ADDENDUM NO. 2

Furnace Bridge - Installation

Essex County, NY

July 29, 2015

PLAN VIEW

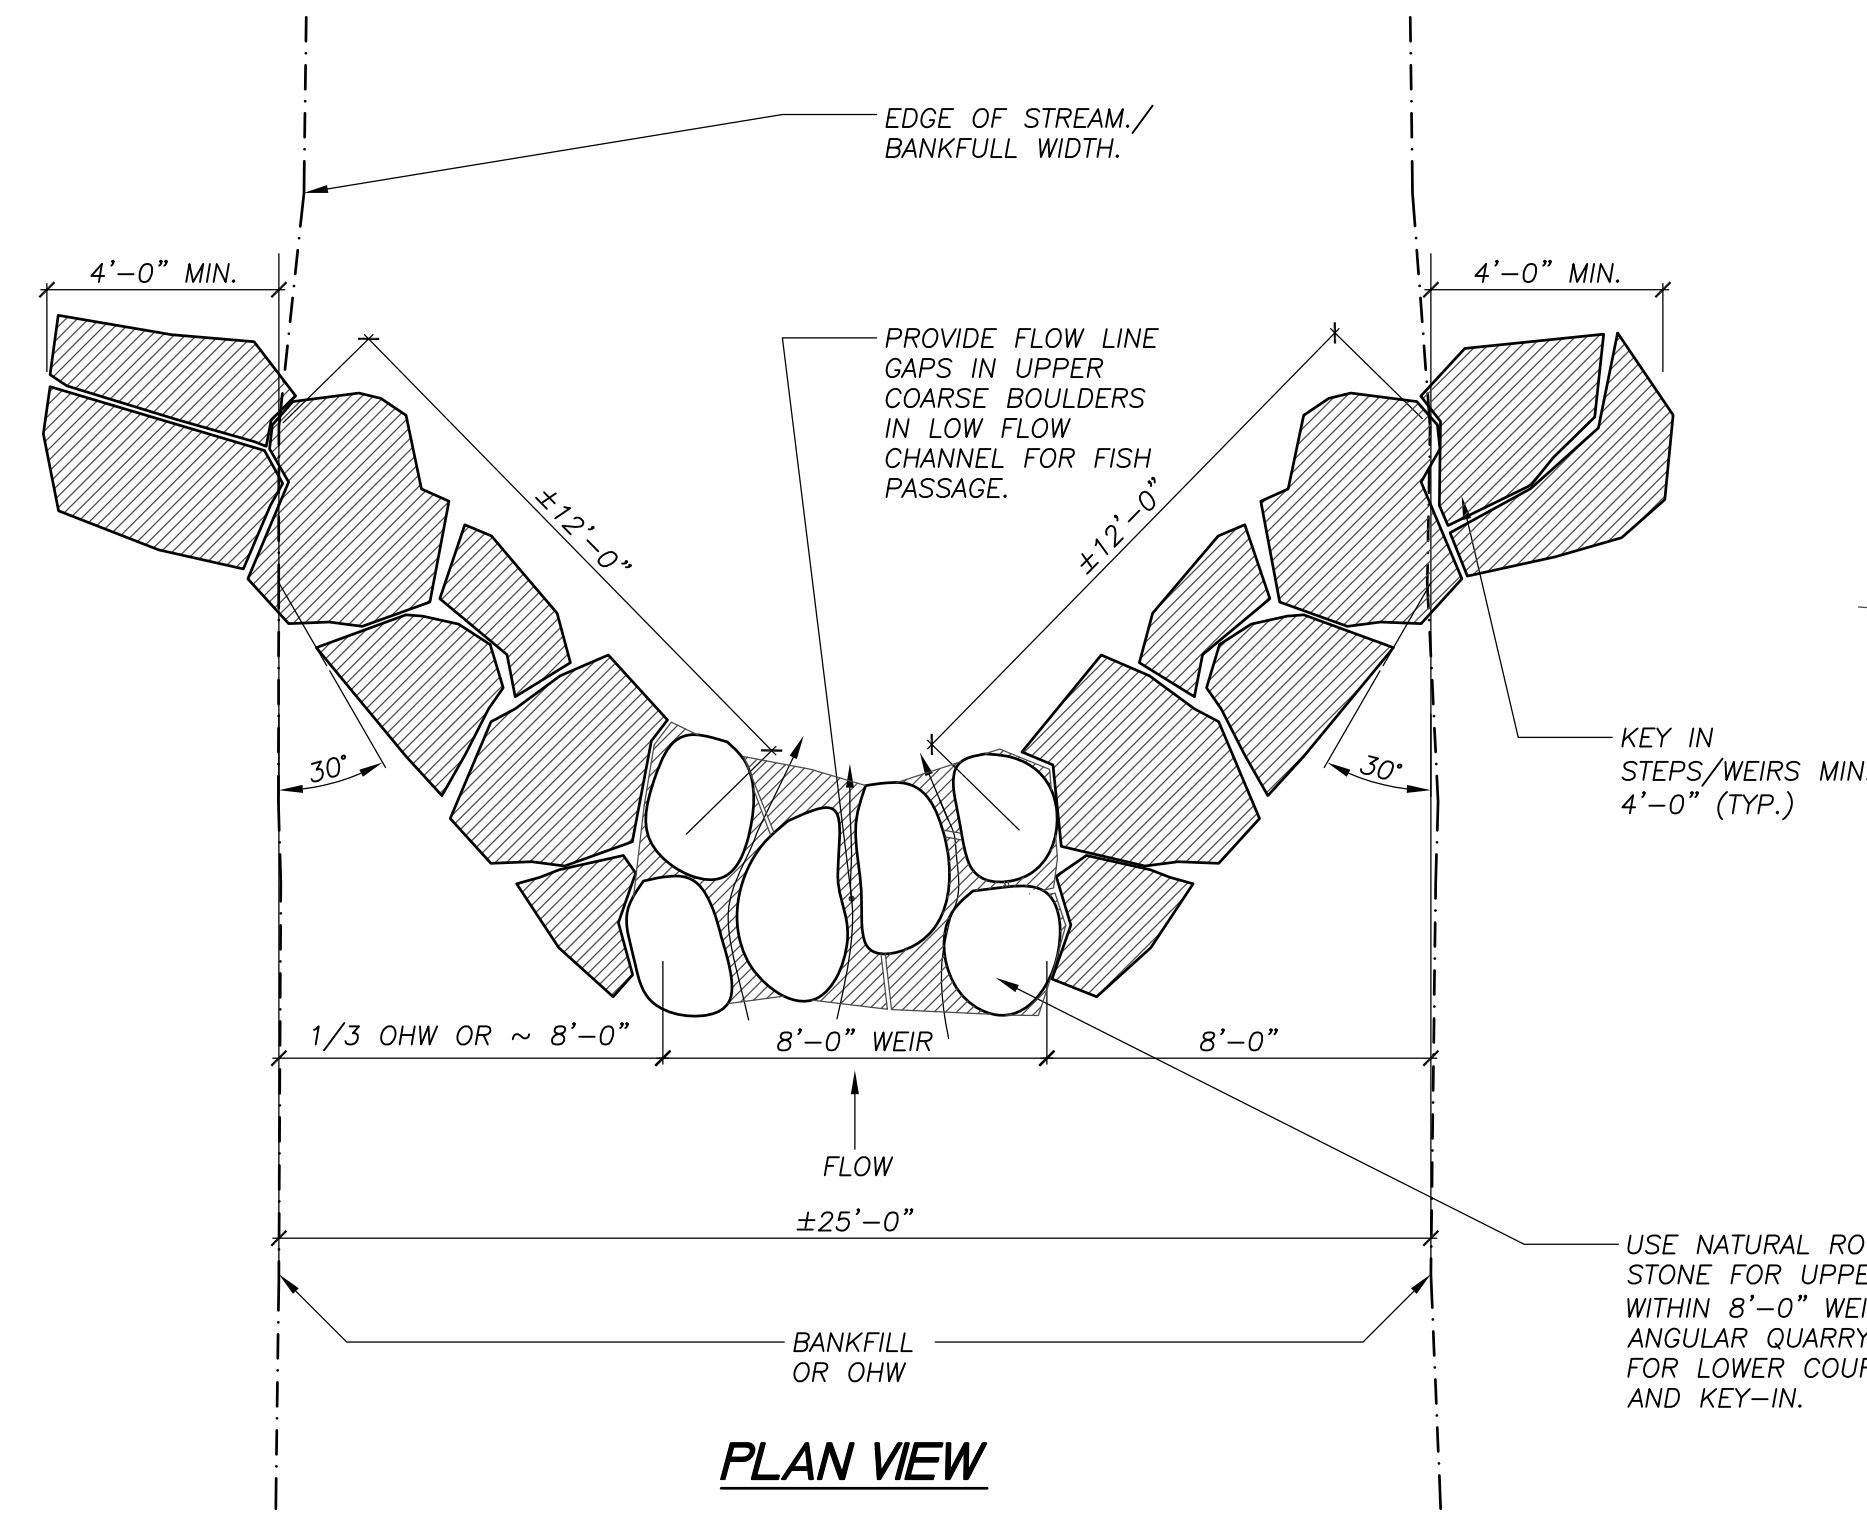
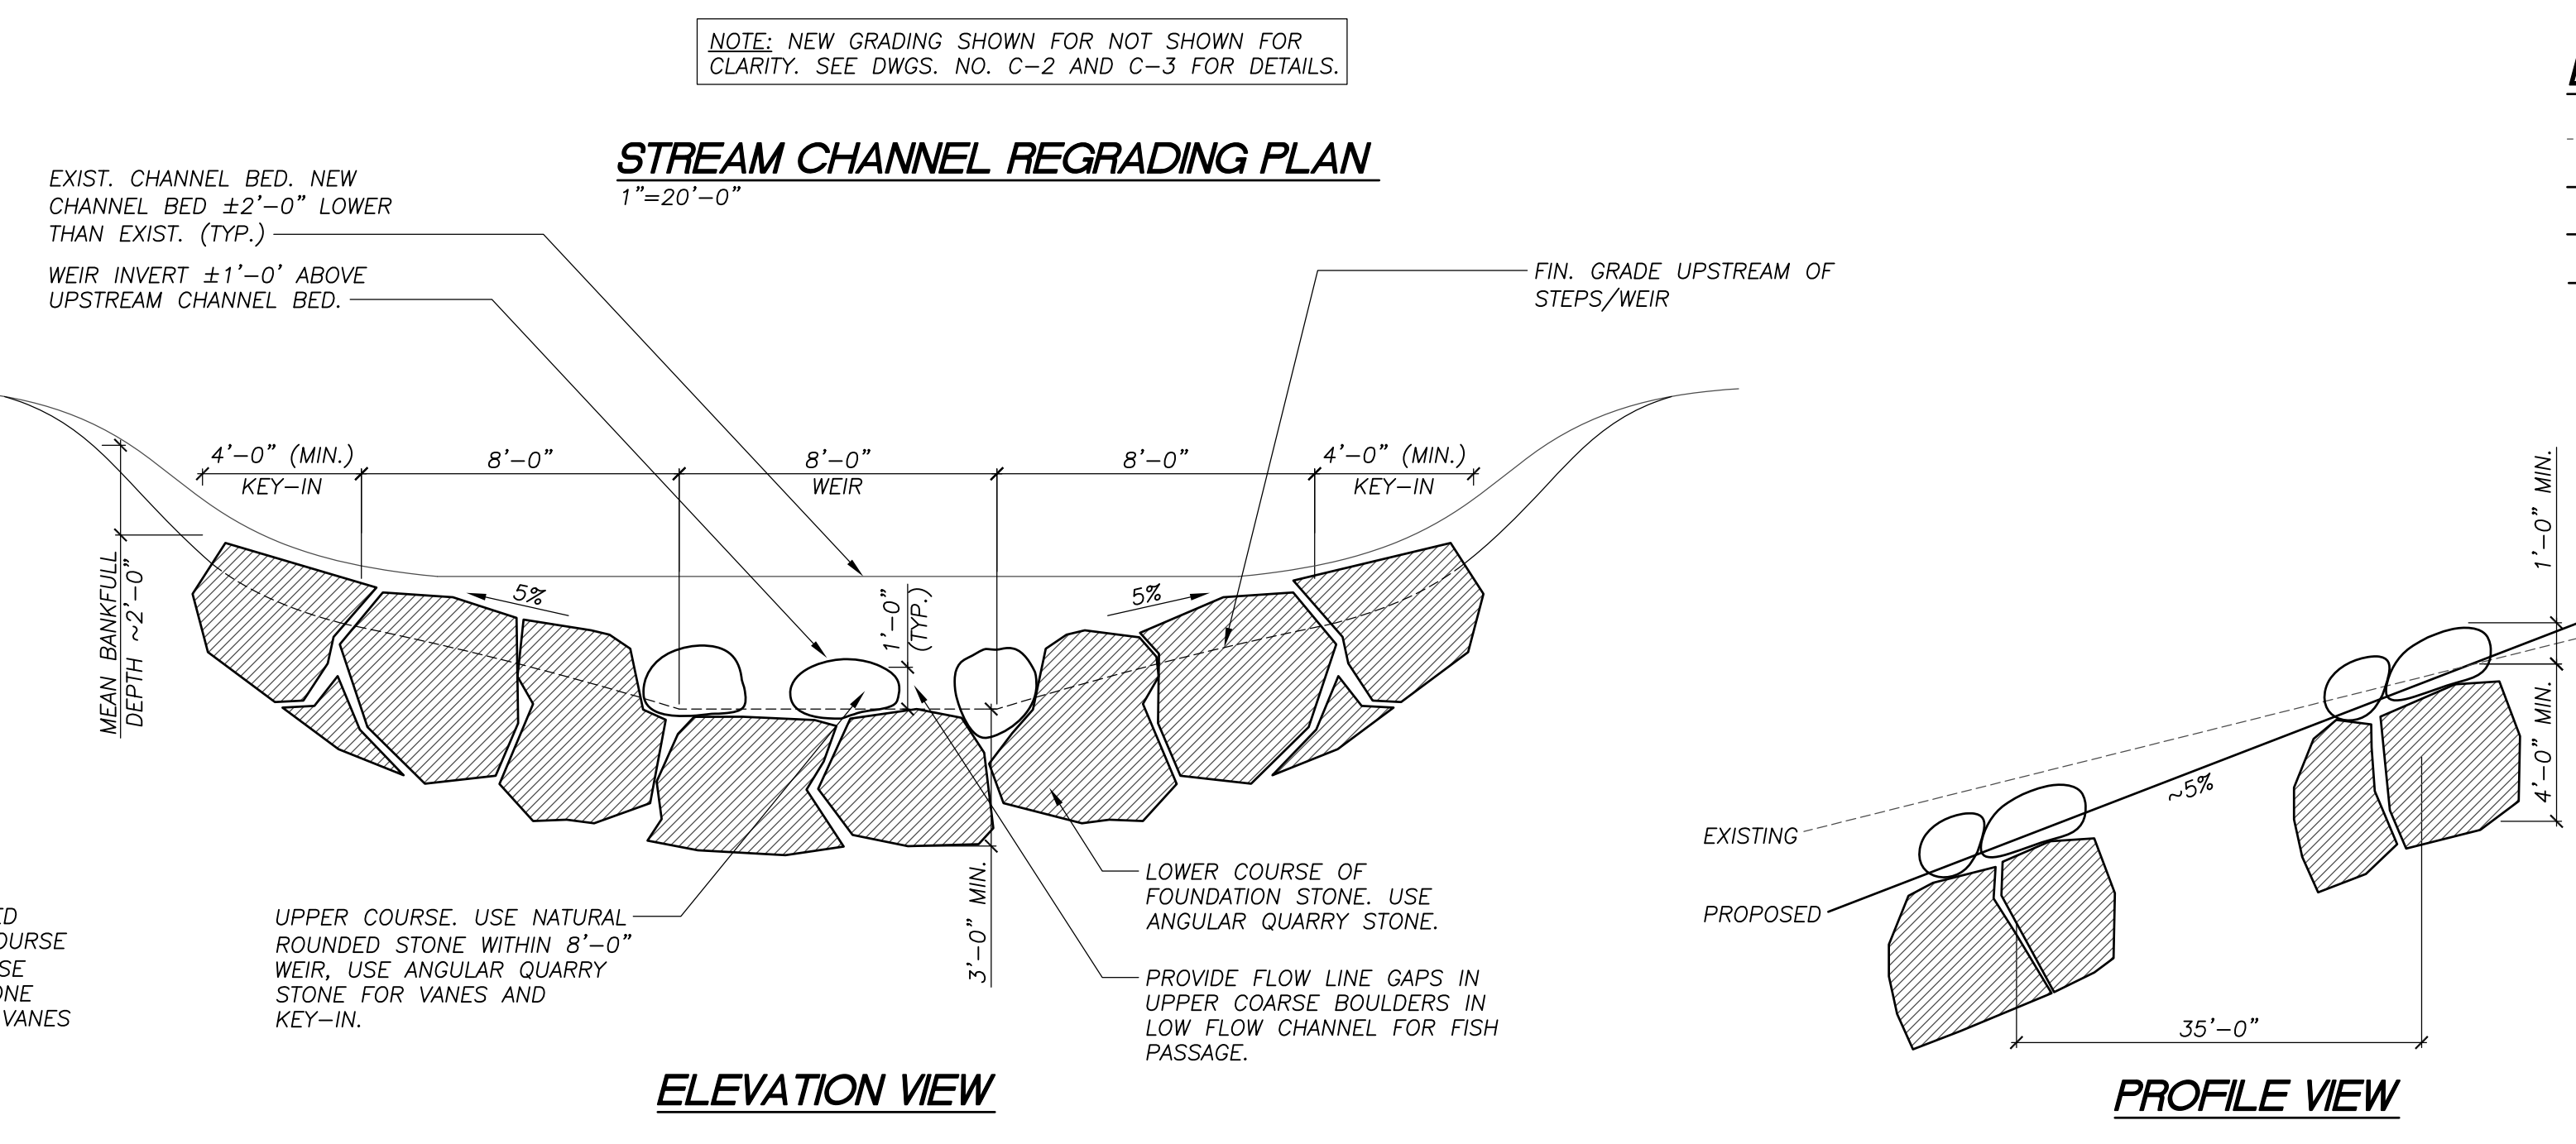
5. **General:** As noted in the Pre-Bid Meeting Minutes included in Addendum No. 1, modifications have been made to the stream channel reconstruction from the information currently indicated on the bidding documents. DELETE the drawing Cover Sheet and Drawing Nos. N-1, C-1 through C-4 and COE-1 and SUBSTITUTE THEREFORE the attached Cover Sheet and Drawing Nos. N-1, C-1 through C-5 and COE-1, all bearing the Revision date 7/29/15 and designation "Issued with Addendum 2". Bidders shall include all costs for the stream channel reconstruction work in their Bid for the project.
